**SUSQUEHANNA STEAM ELECTRIC STATION
SUPPLEMENT TO LICENSE AMENDMENT
REQUESTING ADOPTION OF TSTF-505,
REVISION 2
PLA-7984**

**Docket No. 50-387
and 50-388**

Responses to Regulatory Audit Questions

**Figure Q28-1****Transient Influence Factor Results for Control-Aux-Reactor Generic Location****Figure Q28-2****Transient Influence Factor Results for Turbine Building Generic Location**

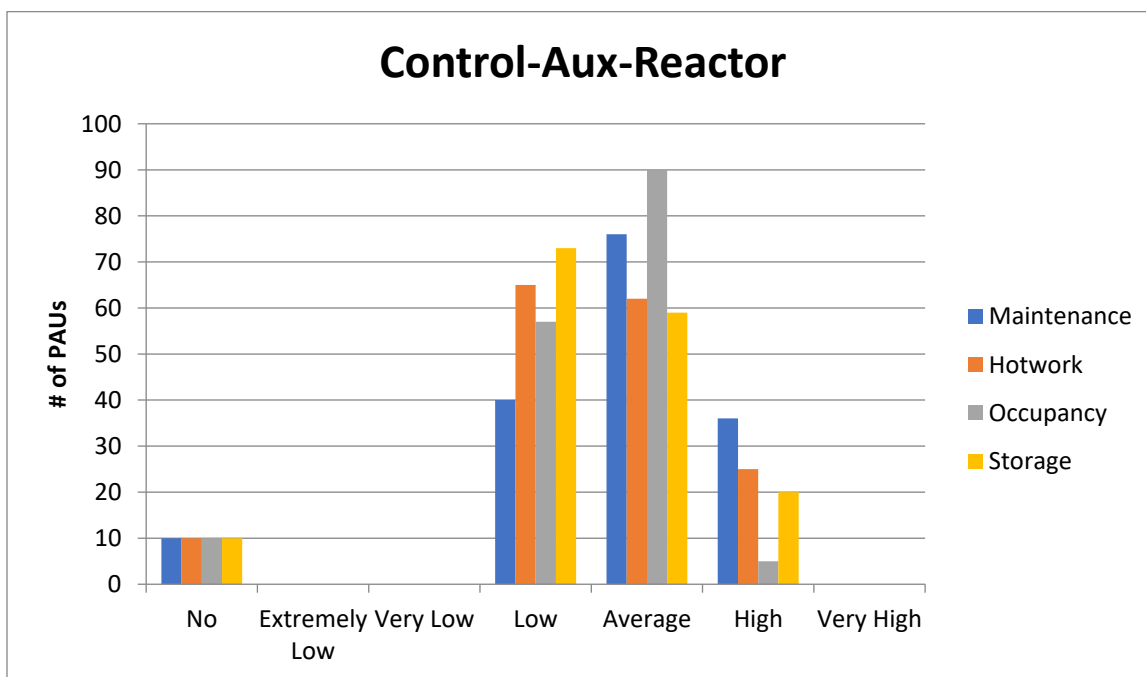
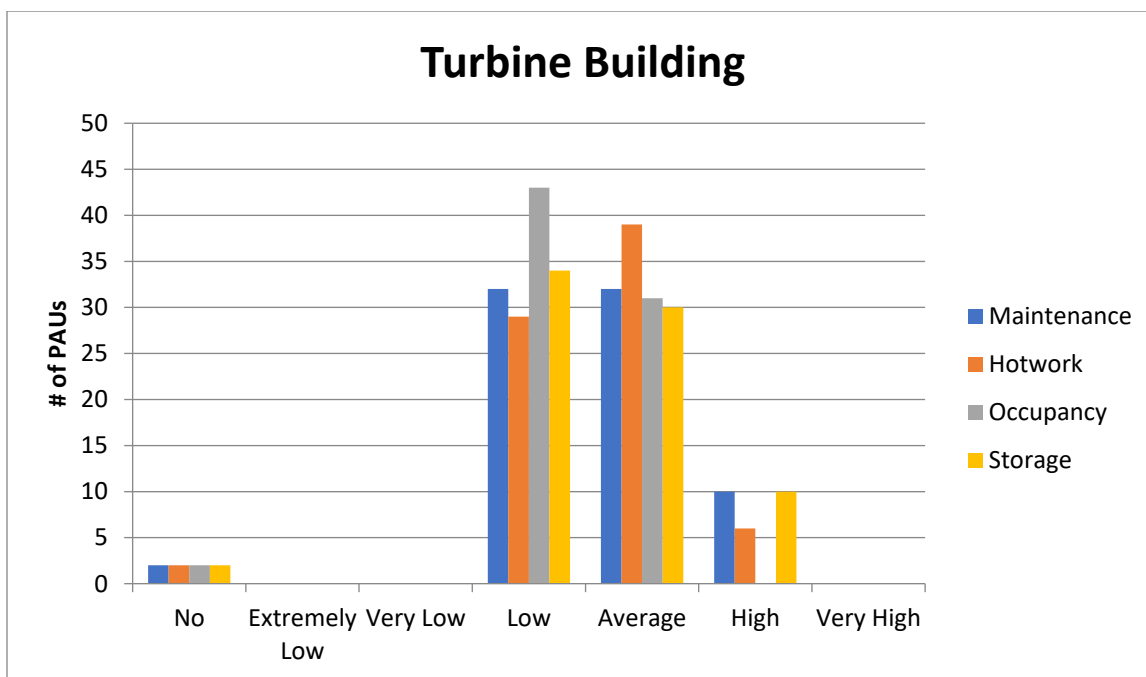
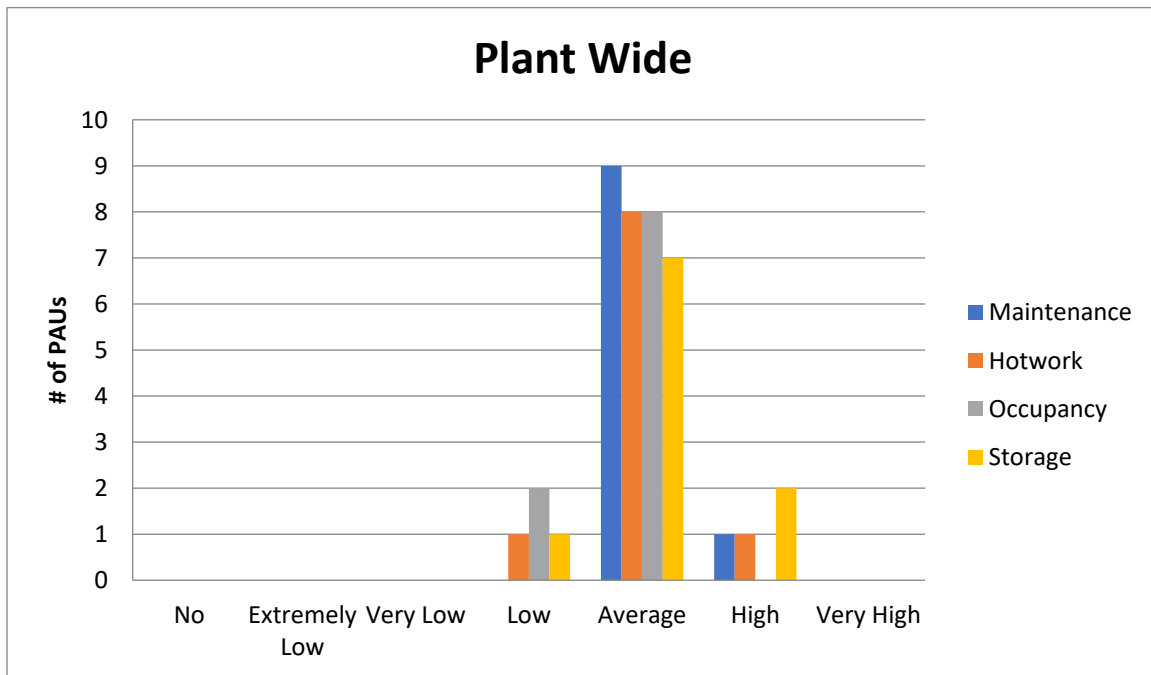
Provide a sensitivity study or other justification demonstrating that assigning weighting factors of “50” per the guidance in FAQ 12-0064 has an inconsequential impact on the RICT calculations.

The Susquehanna FPRA currently does not apply a “very high” transient influence factor (TIF) of 50 (from FAQ 12-0064) to any PAU. FAQ 12-0064 (Reference 49) does not explicitly require the use of the full range of ratings, as shown below:

In order to determine the relative TIF ratings, a panel was held including the plant fire protection engineer and a representative from mechanical maintenance. This panel concluded that no PAUs within the plant generic locations had a level of maintenance or hotwork significantly higher than other PAUs assessed as “high”. Therefore, the “very high” rating was not used. An even distribution is more appropriate given that no PAUs are outliers that would warrant an application of the “very high” factor of 50.

TIFs were assigned to each PAU relative to the other PAUs within the same plant area (Control-Aux-Reactor, Turbine Building, or Plant Wide). A summary of the results of the relative rankings of each PAU within the generic locations are shown in the figures below. In the bar graphs, the vertical axis shows the number of PAUs in each generic location assigned to each of the influence factors. In general, these graphs show that the distribution of TIFs meets the intent of the FAQ by following a bell curve shape with a majority of the PAUs assigned to the “average” factor. No PAUs are assigned to “extremely low”, “very low”, or “very high” ratings.

For these PAUs, the maintenance and hotwork categories were elevated from “high” to “very high” as a bounding assessment. This change resulted in an increase in the full-room burnup TIF from 8.23E-04 per year to 3.11E-03 per year for each PAU. Table Q28-1 summarizes the results of this sensitivity on a sample of TSTF-505 RICT calculations. The sample TS cases were selected because they represent the cases that would most likely be impacted by the assumption and produce RICT estimates less than 30 days.
